CIRCLE SQUARE PLOTS 2, 3 + 4
(FORMERLY KNOWN AS BBC SITE)
OXFORD ROAD, MANCHESTER

Non-Material Amendments
April 2020

2.2 Signage Elevations

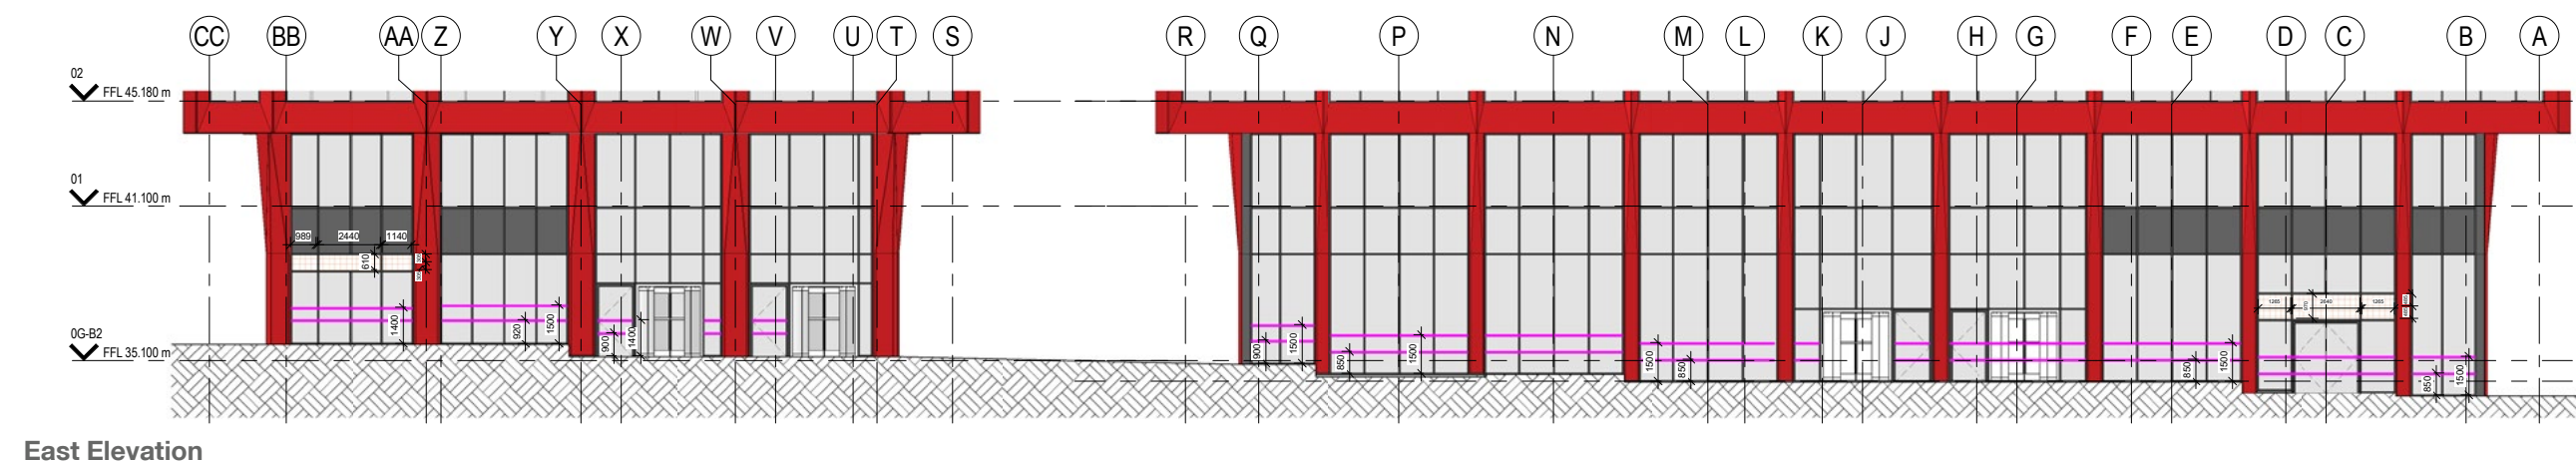
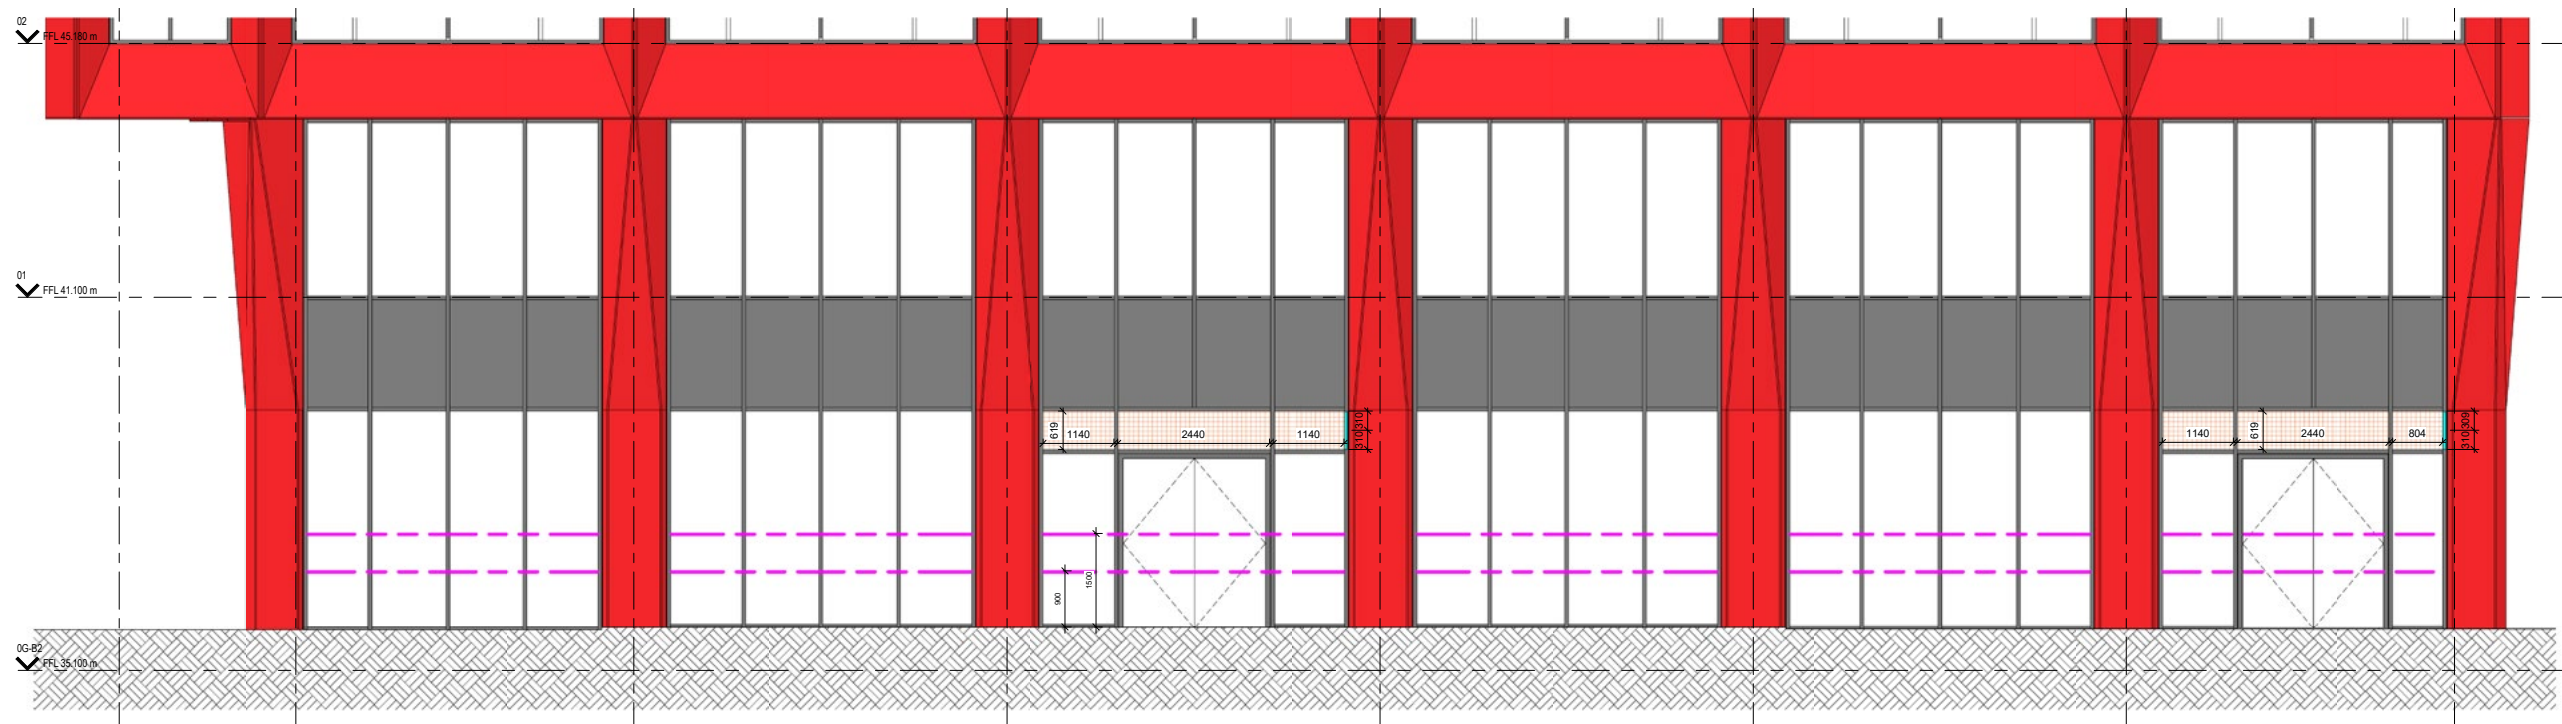
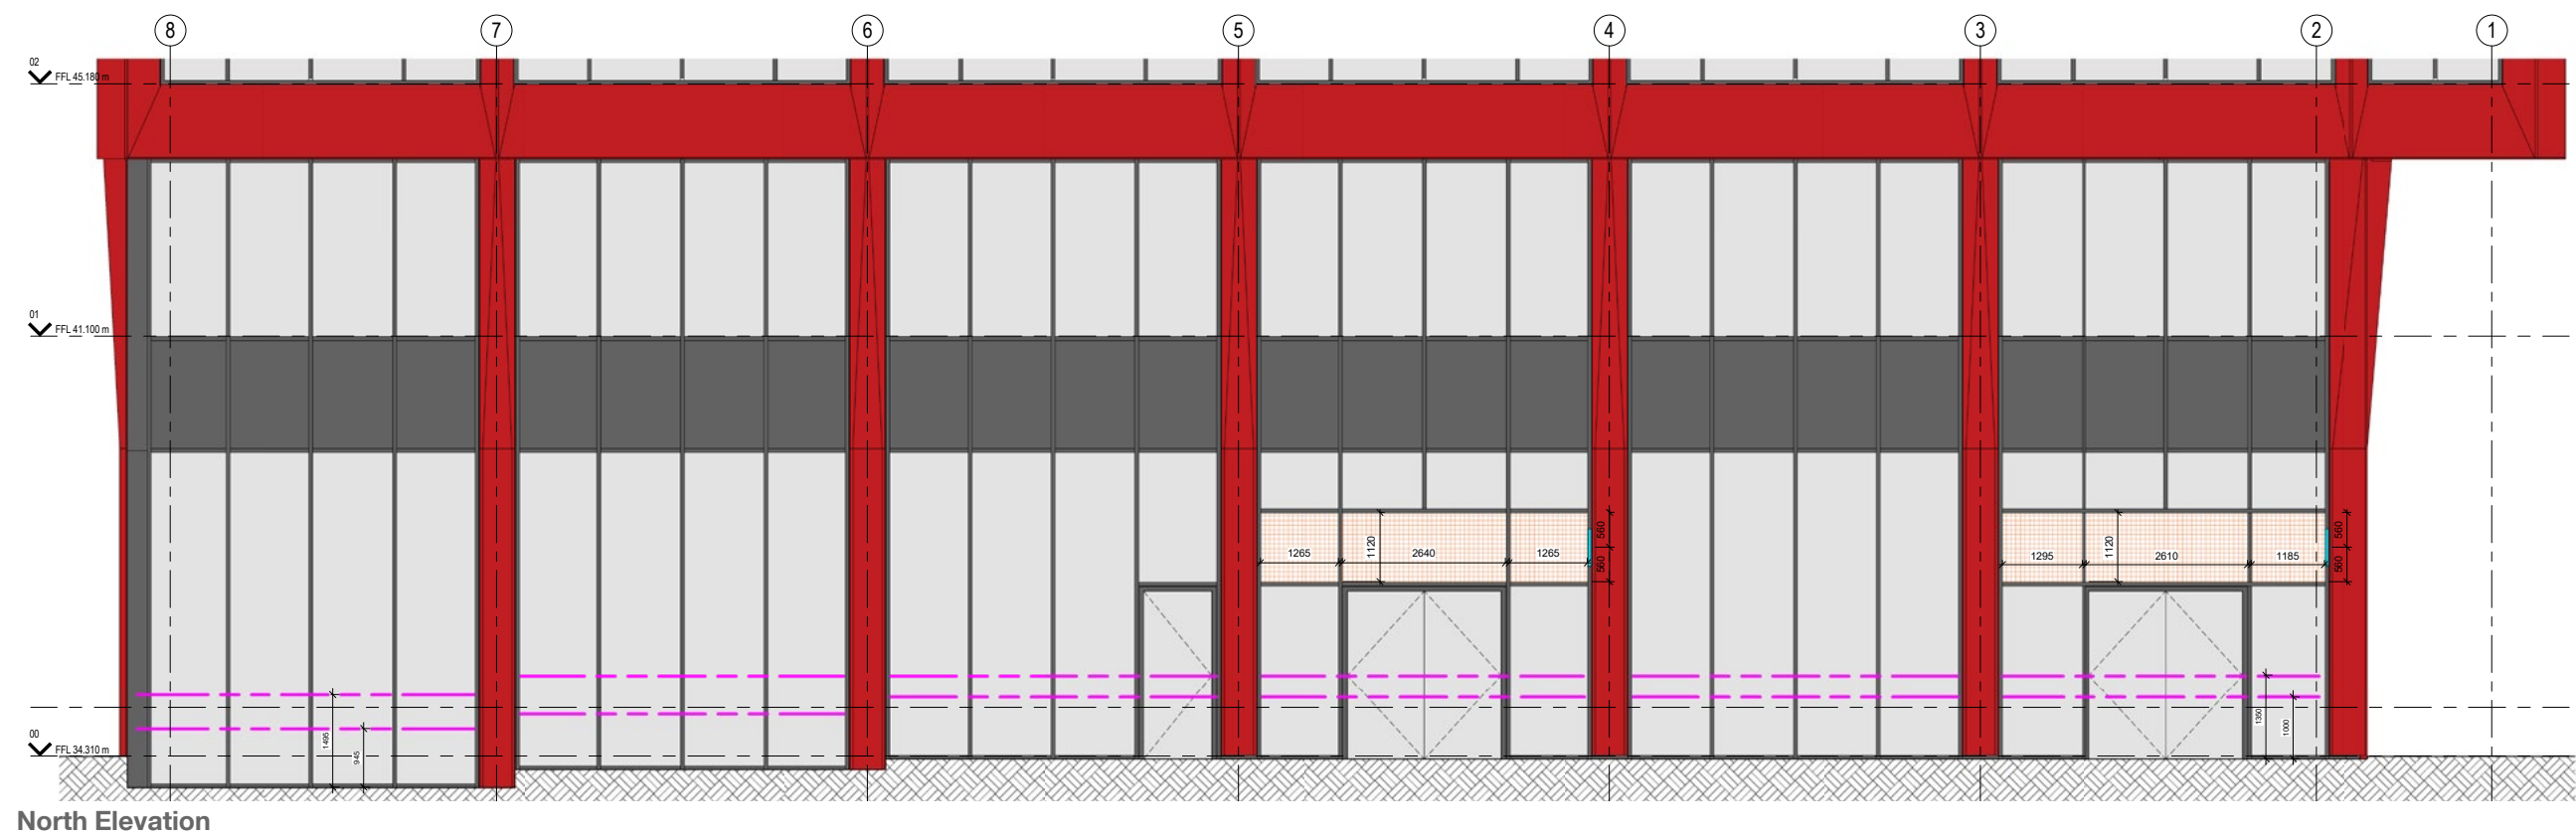
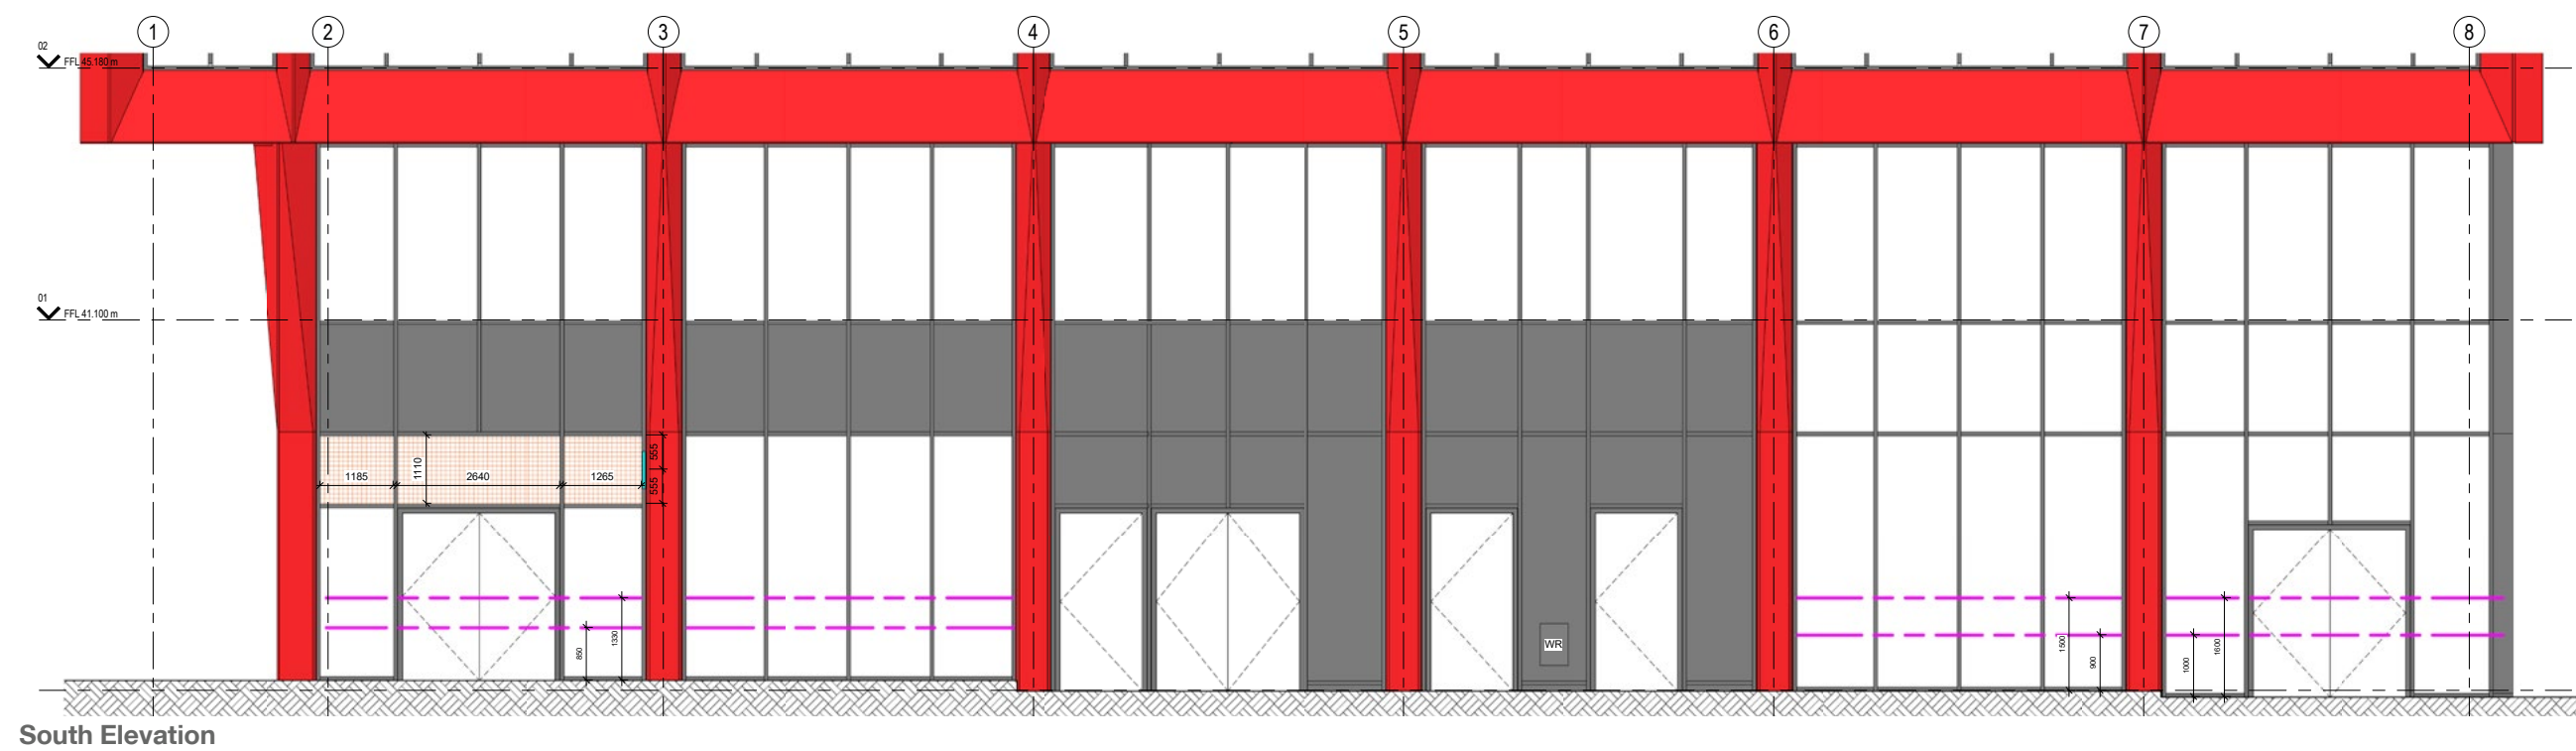
Signage panels to retail spaces increased to span the whole bay.

Above door signage zone
(final design to tenant spec)

Bus stop signage
(shown in light blue on signage elevations)

3.1 Roof vents - Level 17

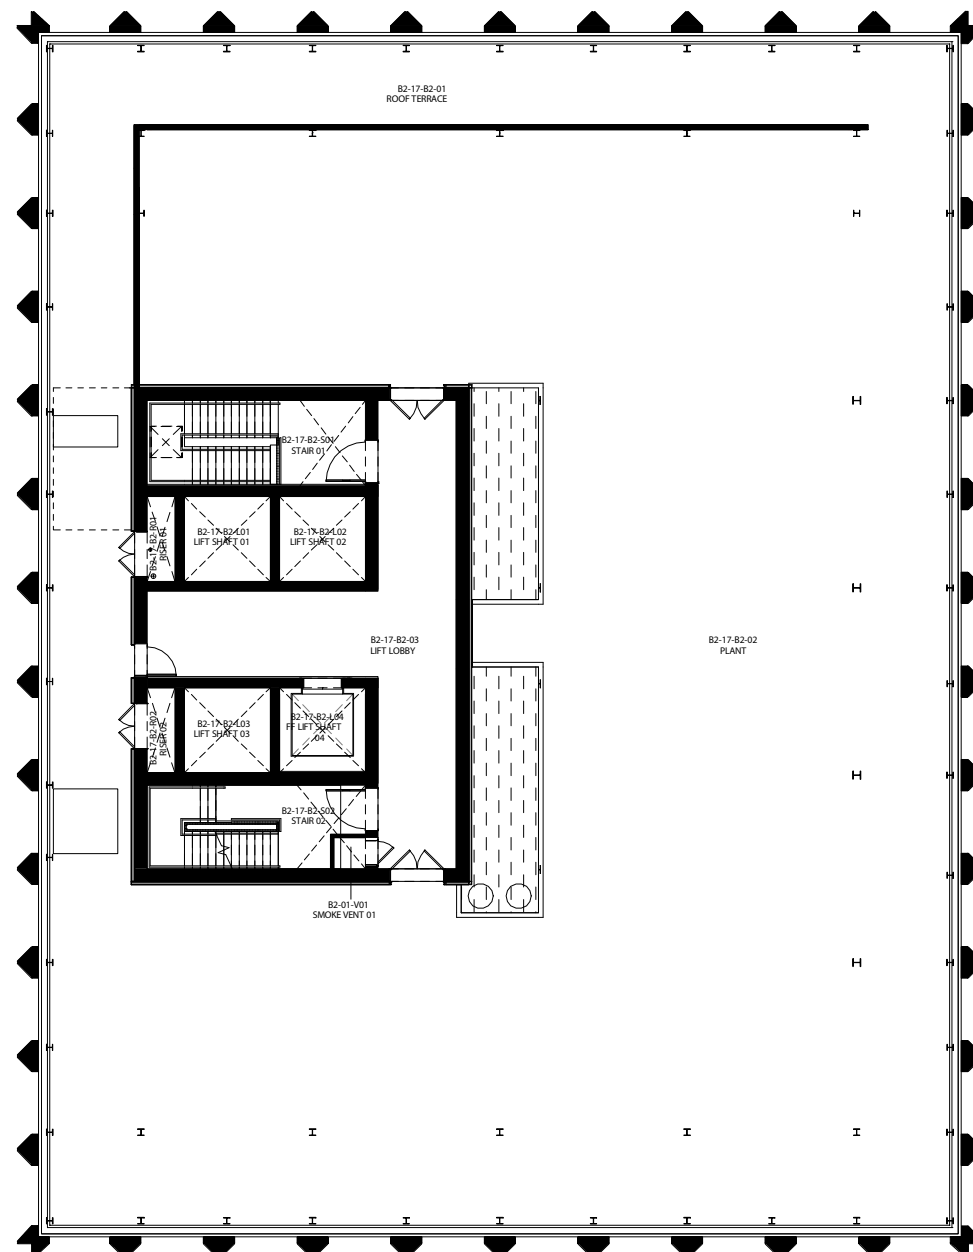
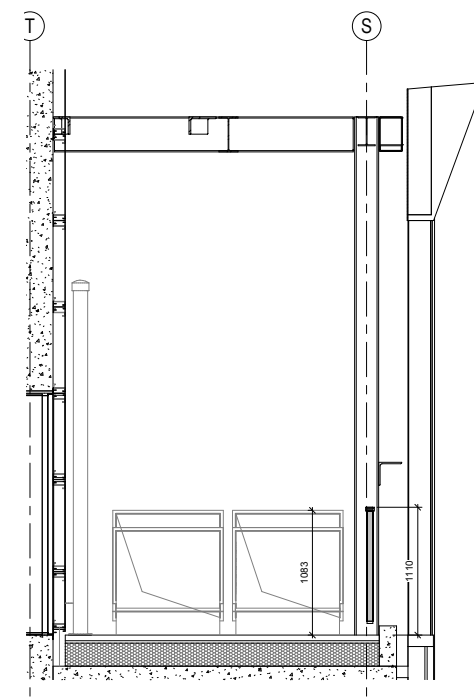
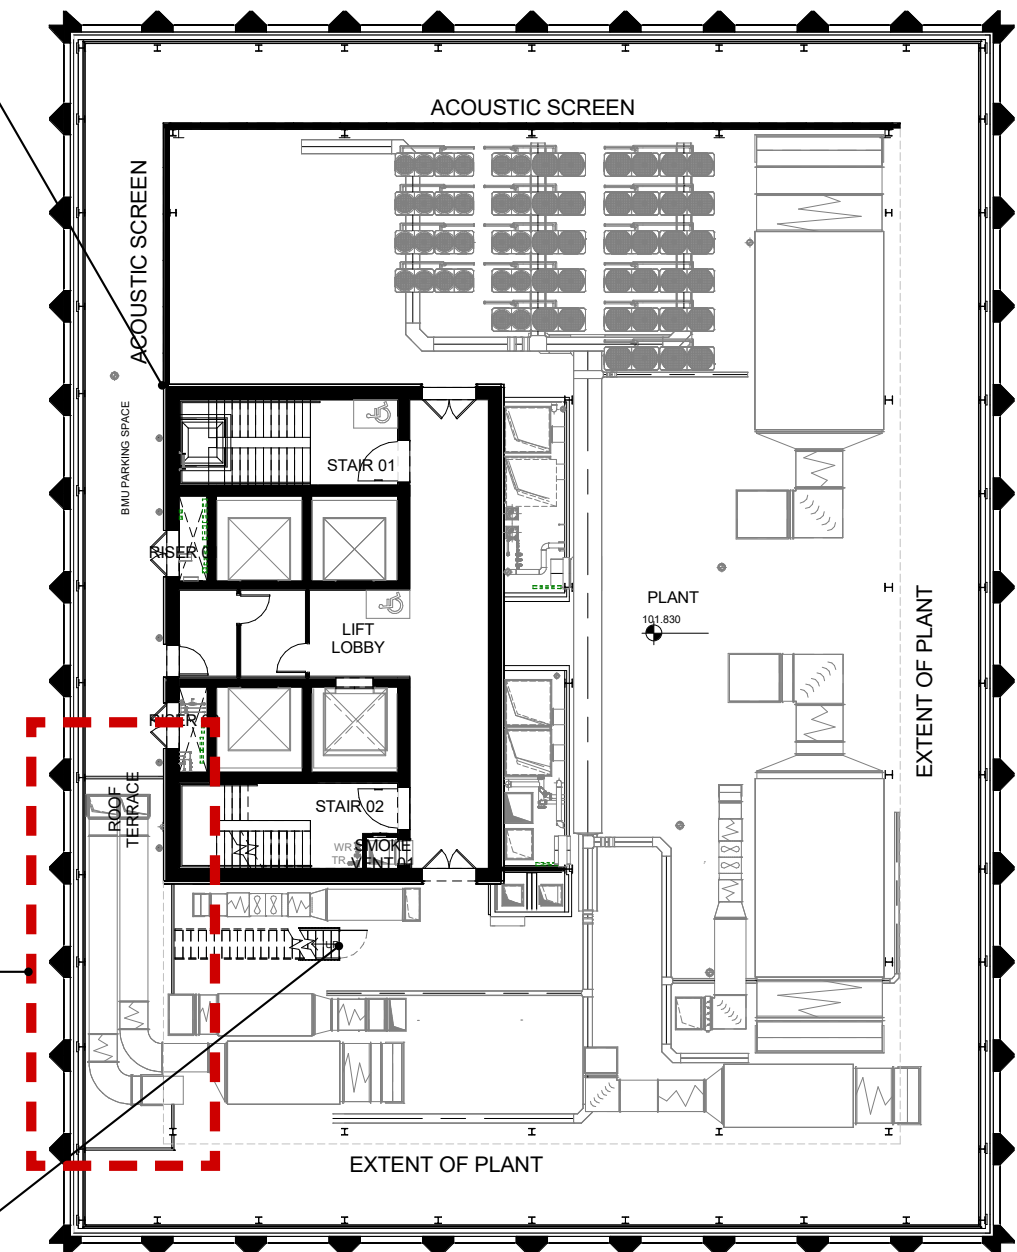
Due to access restrictions and a dense plant space on the roof of Building 2, two low level vents will sit behind the 1100mm metal balustrade for two bays on the northern facade.

Line of acoustic panels slightly moved towards facade

Section of ductwork against the perimeter but below the height of the balustrade (section above)

Please note: There is barrier guarding around the vents to close off access.

Access ladder up to the BMU track with full gate enclosure.
